# Residential Product Group Product Update Notification

### **Product Update Notification:**

## **Packaged Cylinders & Hydrobox**

#### **Product Packaging Identification:**

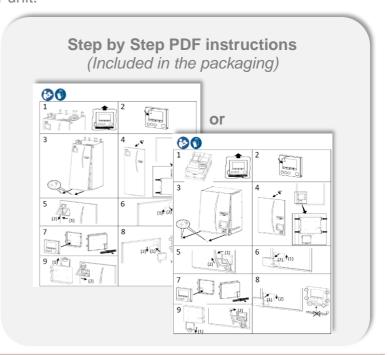
• The current Main RC will **not** be installed into the front panel of the indoor unit and will be located on top of the product supplied within the original product packaging.

• Please install the current main RC (as identified by multiple <u>yellow</u> stickers on the packaging) on site, using the guidance provided.

- 1. A yellow sticker indicates the product was initially supplied to the warehouse without main RC.
- 2. A tick indicates the main RC has been added.

Install the current main RC into the indoor unit.
